SOUTH GIPPSLAND SHIRE COUNCIL  
**FLOOD AND DRAINAGE STUDY FOR FOSTER AND SURROUNDING CATCHMENTS**

The following table contains collated comments in response to the following report:

Feedback	Flag	DELWP comments / Suggested response	Action/comments from consultant
<b>Review 1</b>			
<b>Assessment of response by Engeny to review comments on the first version of the hydrology report</b>			
The collated comments on the hydrology report, and Engeny's responses, are published as Appendix A in the hydraulics report (Engeny, 2018). I have assessed Engeny's responses and annotated the Appendix (attached to this memo). Most of the responses are appropriate. The following list highlights some key remaining issues.			
<u>Climate change</u> The reviewers noted that climate change had not been addressed. Engeny has still not attended to climate change in the revised hydrology report, or the hydraulics report, but do state that it will be addressed in a risk mitigation report. This remains to be delivered.			Engeny has completed its Climate Change investigation and has discussed the outcomes and provided outputs as necessary.

<p><i>Outflow Boundaries</i></p>

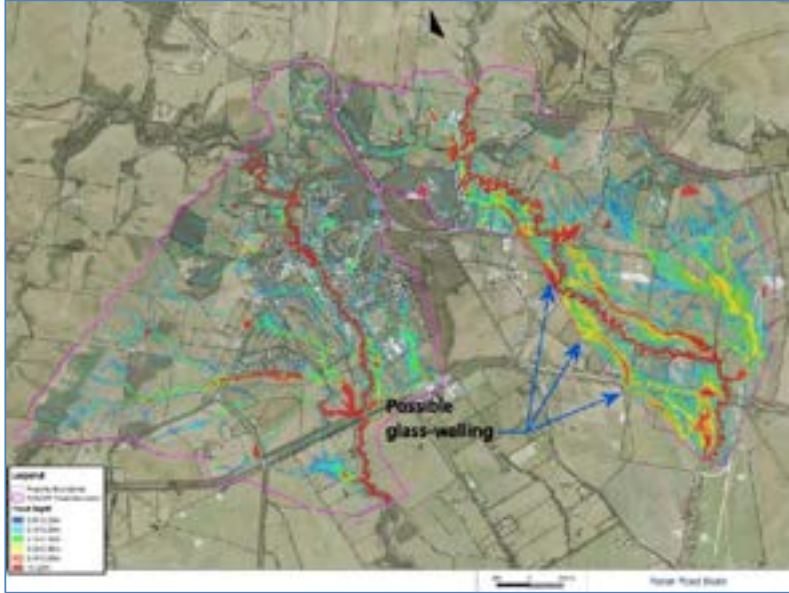
Feedback	Flag	DELWP comments / Suggested response	Action/comments from consultant
<p>Head versus flow relationships have been provided at all locations where flows exit the models. These can be seen on the TUFLOW model layout for Bennison Creek but as the model layout for Stockyard Creek focusses on the town of Foster the outflow boundaries can't be seen on that layout. A separate Figure should be provided for the entire Stockyard Creek catchment.</p> <p>Please see <a href="#">Question 10</a> below.</p>			
<p><u>Whether the assumptions around waterway blockage at culverts and bridges were reasonable.</u></p> <p>At a community information session it was widely reported by residents that blockage of the Boundary Road culvert occurred during the 2016 event, and that they strongly believe this blockage contributed to the flooding in Boyd Court. The extent of blockage is unknown. For the modelling, ENGENY adopted a 50% blockage factor and ran 2 or 3 storm durations for the 10%, 5% and 2% AEP events.</p> <p>Appendix E of ENGENY's report provides a flood extent for a 2% AEP event, with blockage at Boundary Road. Table 3.4 of ENGENY's Data Report mentions that for some of the pits it has been assumed that only 70% of the inlet area is available for inflows due to the presence of bars.</p> <p>These are all reasonable assumptions.</p>
